SUBJECT: MANAGEMENT MEETING WITH THE U.S. DEPARTMENT OF ENERGY ON CHANGES
BEING CONSIDERED FOR THE EXPLORATORY STUDIES FACILITY

ESF CHANGES UNDER CONSIDERATION

ESF Changes Under Consideration

Enhanced ESF Layout

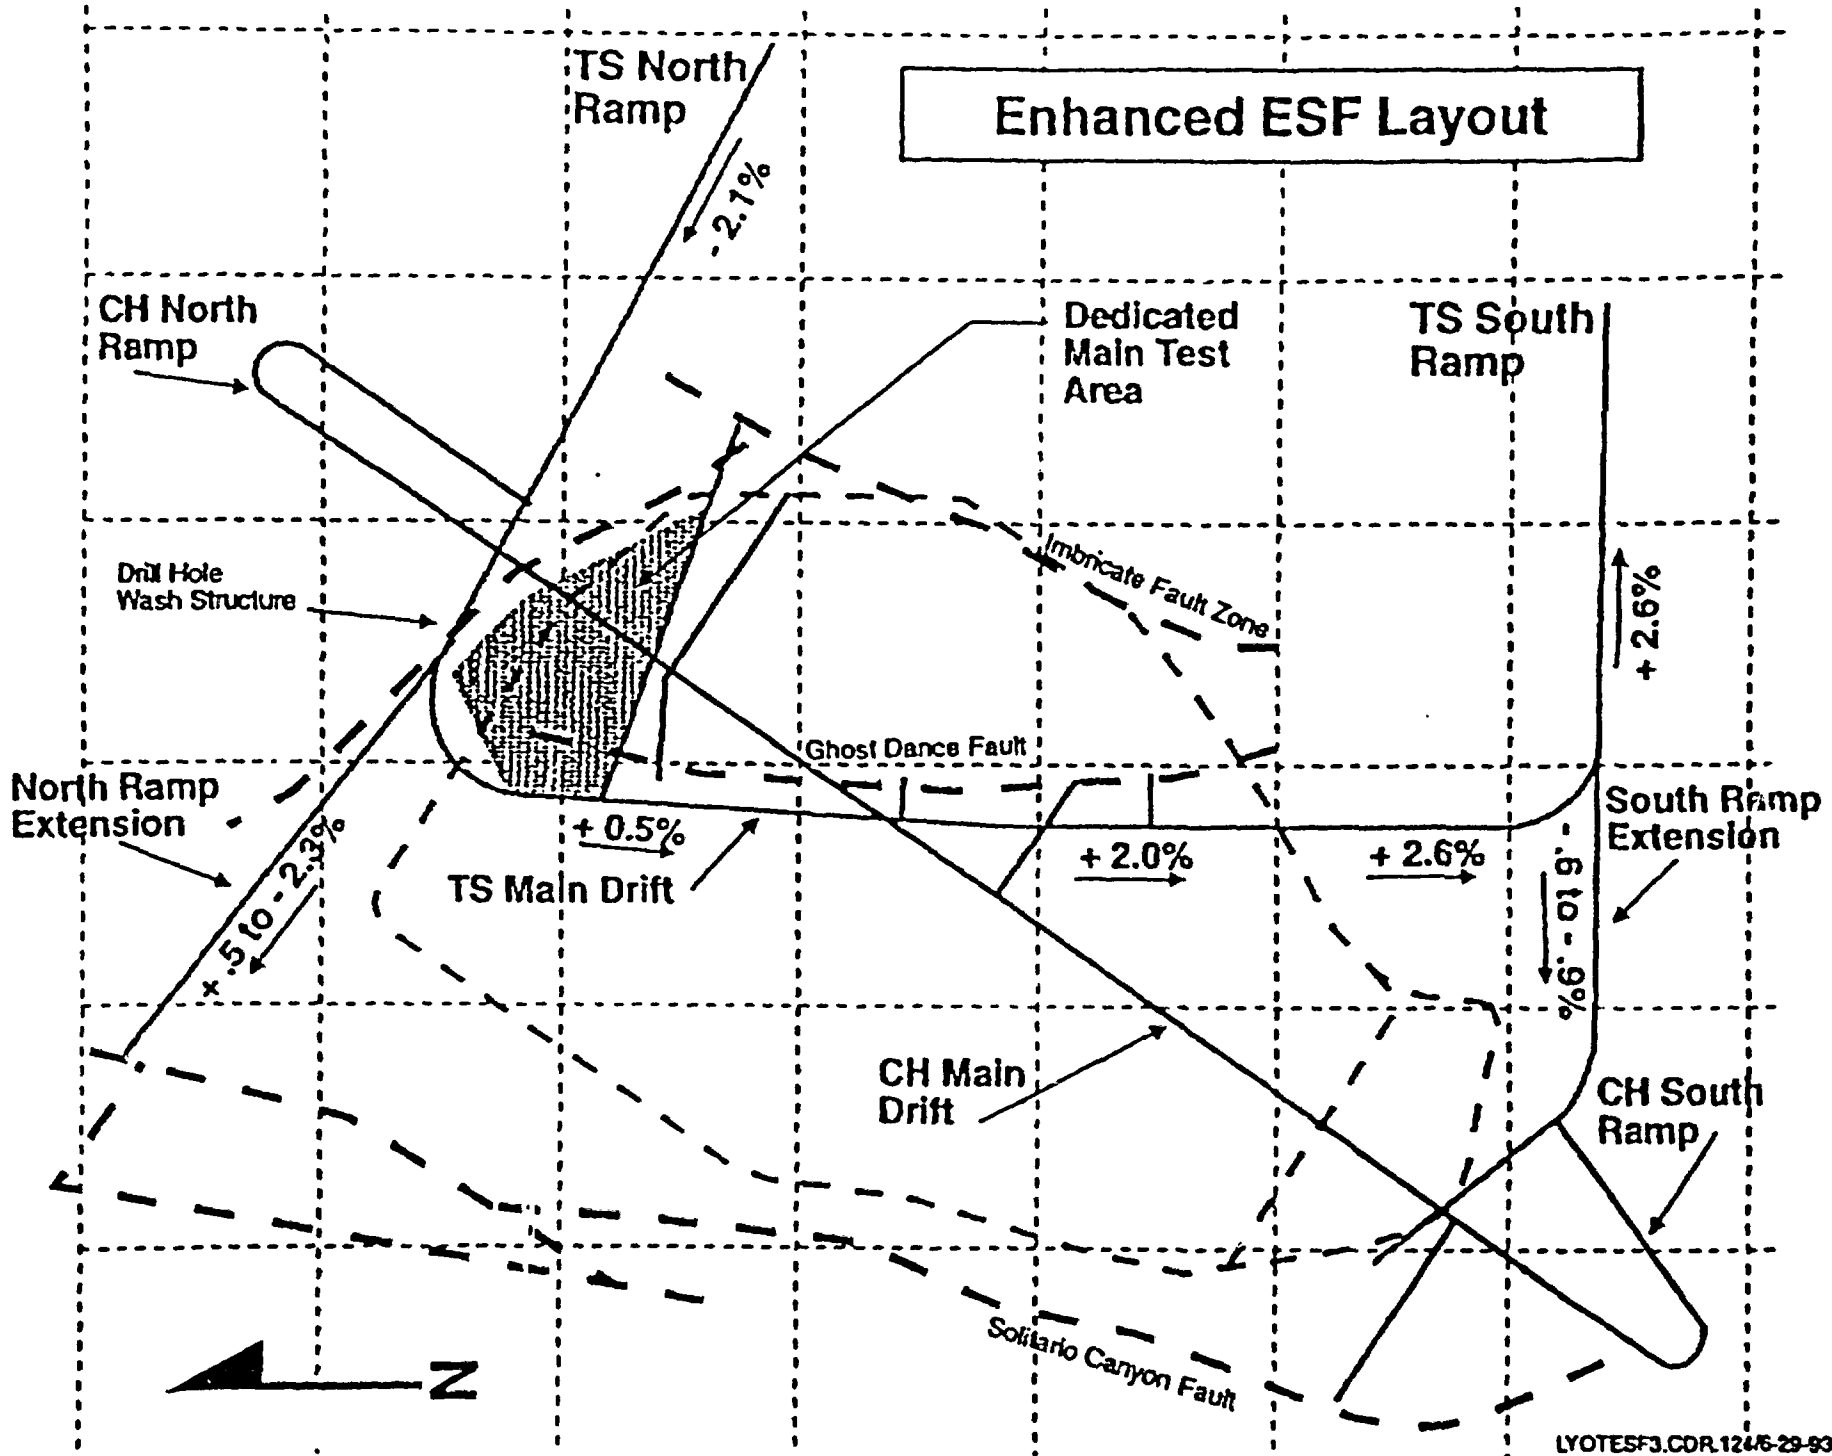
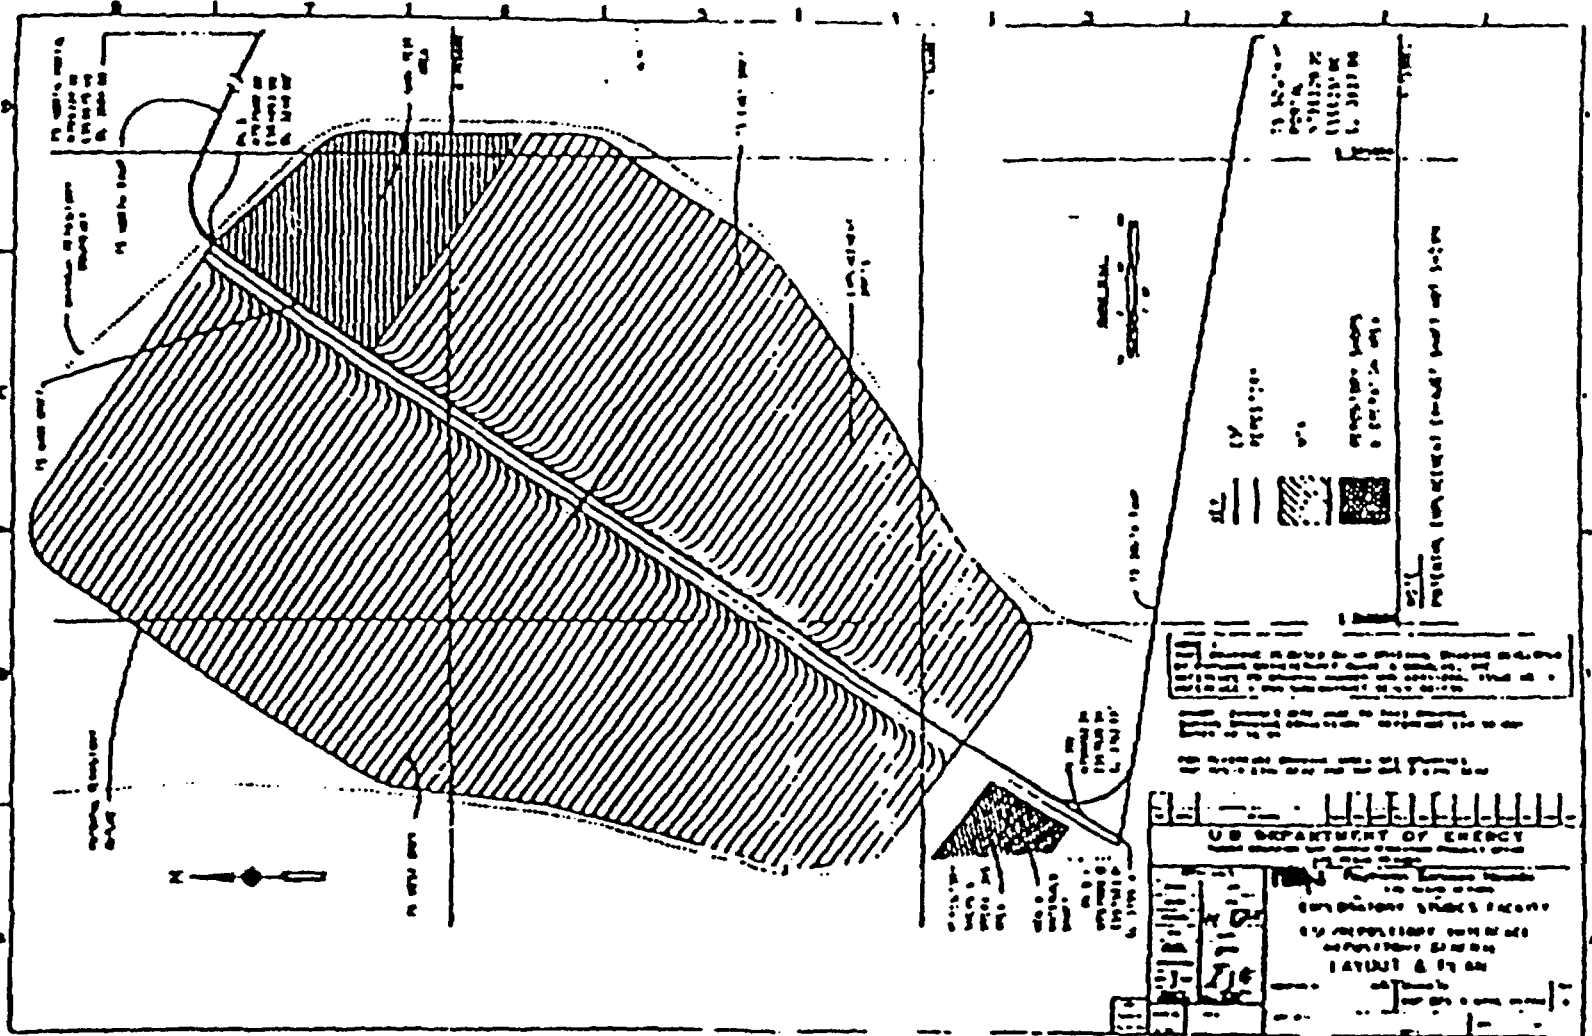
AN ENHANCEMENT TO THE CURRENT ESF LAYOUT HAS BEEN DEVELOPED WHICH WOULD:

- **Maintain the portal location and azimuth of the North Ramp**
- **Result in having no grade in excess of 2.7% in the North Ramp, Main TSL drift, and South Ramp**
- **Preserve repository design flexibility to a much greater degree than the current configuration, including concepts which increase the distance from emplacement drifts to the water table**

- Better accommodate repository layouts having flat emplacement drifts, and layouts which seek to avoid having emplacement drifts cross the Ghost Dance Fault
- Maintain the full scope of site suitability and characterization testing provided by Option 30, and significantly enhance the characterization of the Ghost Dance without affecting repository layout flexibility

- **Enhances Site Characterization ability**
 - **Multiple Ghost Dance Fault contacts can be made with relative ease**
 - **Two Solitario Canyon Fault contacts are planned instead of one**
 - **Ramp extensions give a good look at a large percentage of the vertical extent of the TSw2 interval**
- **Enhances Repository Design Flexibility**
 - **Preserves option for conventional rail haulage**
 - **Preserves option to increase distance from emplacement drifts to water table**
 - **Preserves option to avoid multiple crossings of Ghost Dance Fault with emplacement drifts**
 - **Does not preclude any conceivable repository layout option**

- **Enhances ESF Constructability**
 - **Flatter slopes significantly improve safety aspects of underground operations**
 - **Flatter slopes allow servicing the TBM using conventional rail haulage--as is the norm in virtually all TBM tunnels of comparable length**

Proposed Revisions to Surface Based Testing Program

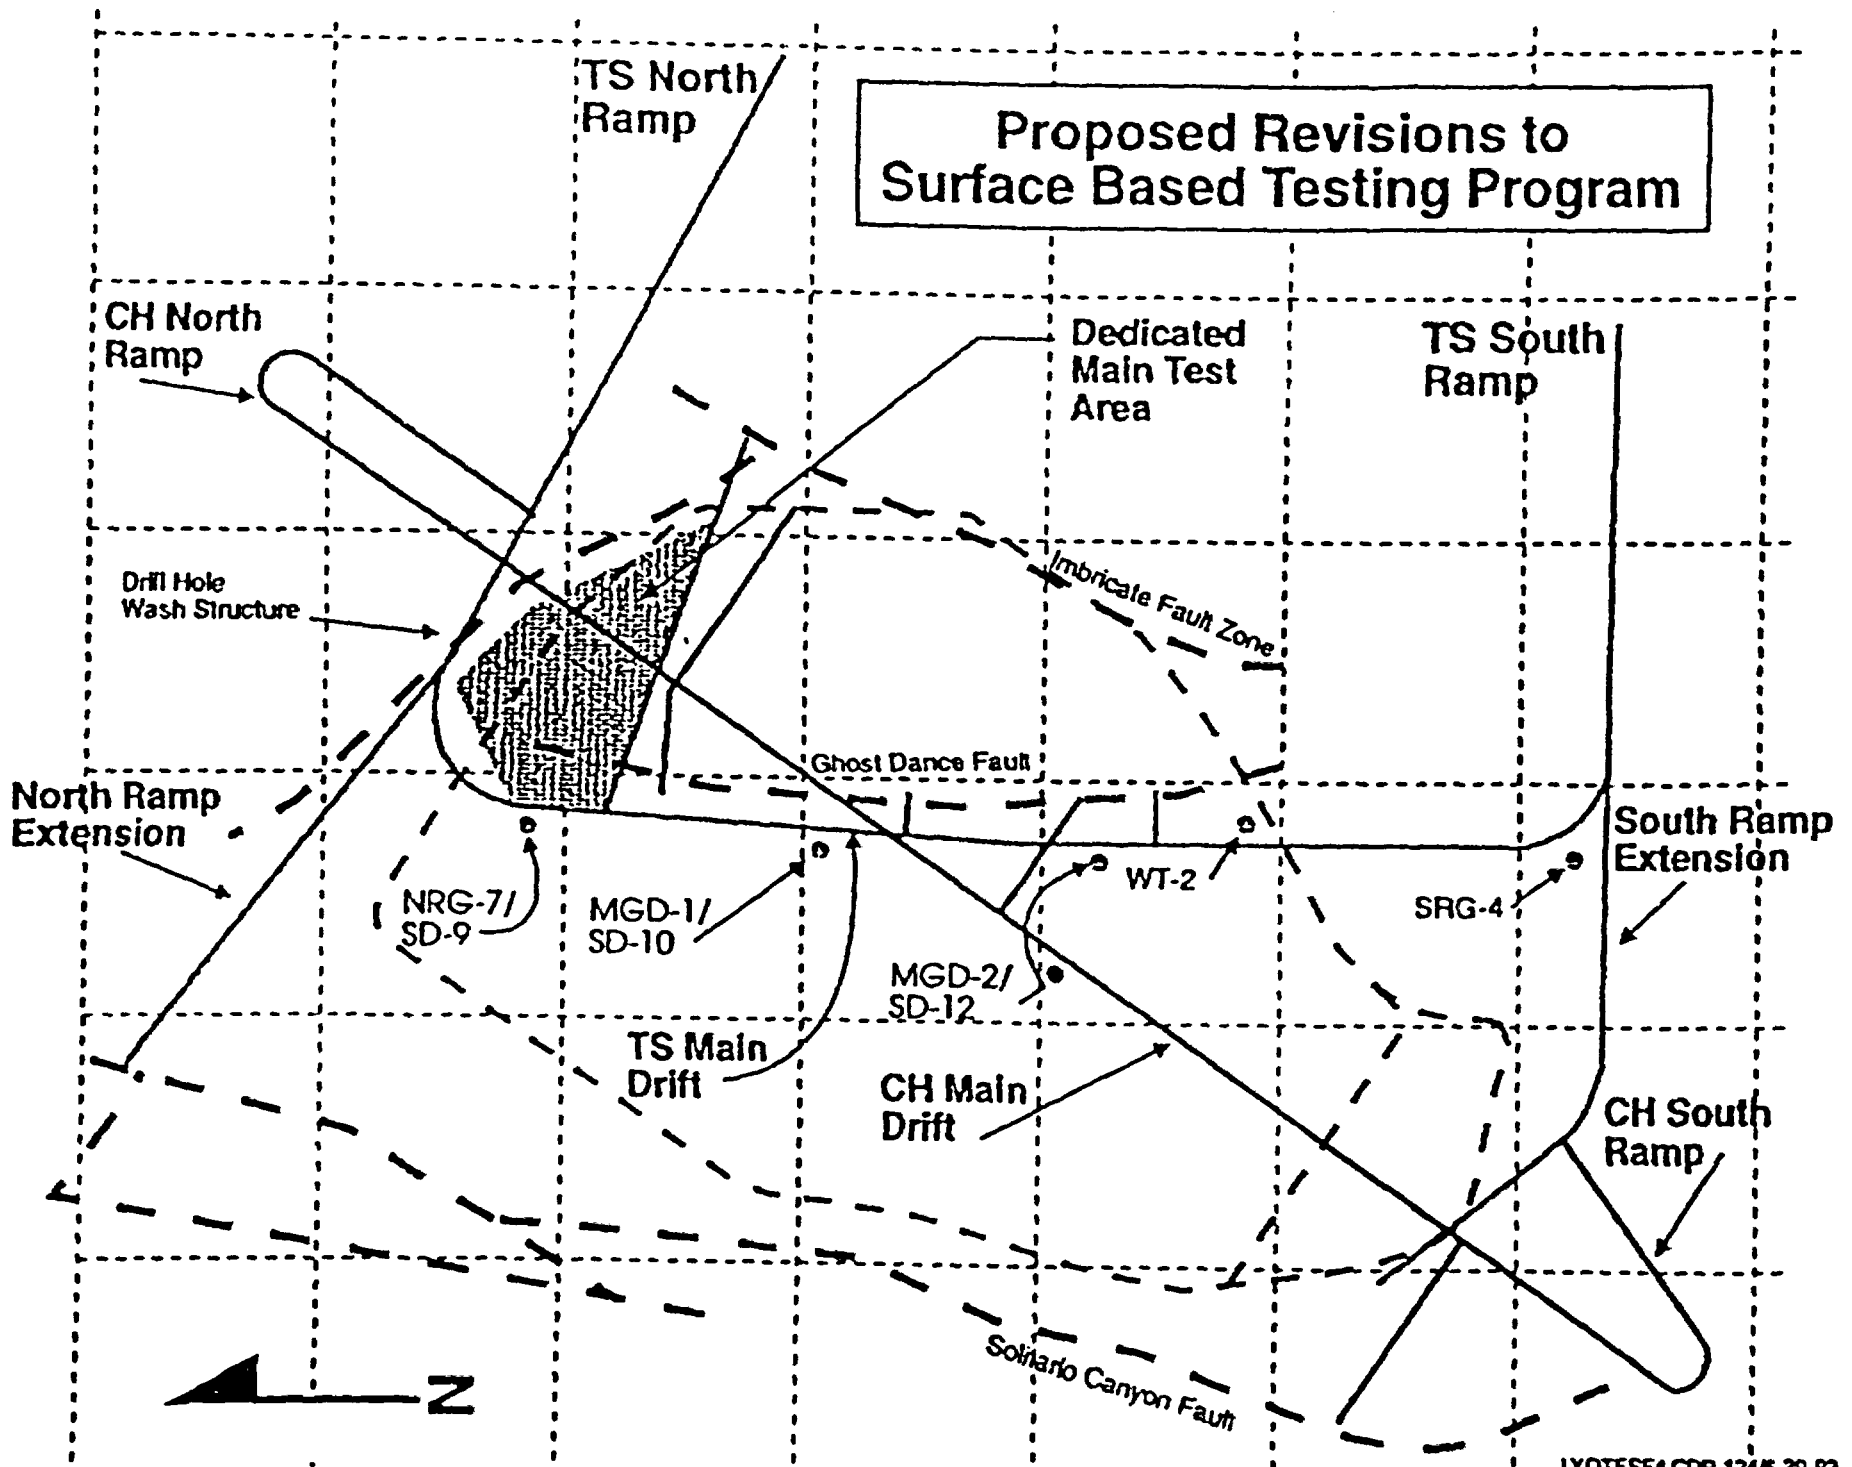
SBT ADJUSTMENTS TO SUPPORT ESF RECONFIGURATION
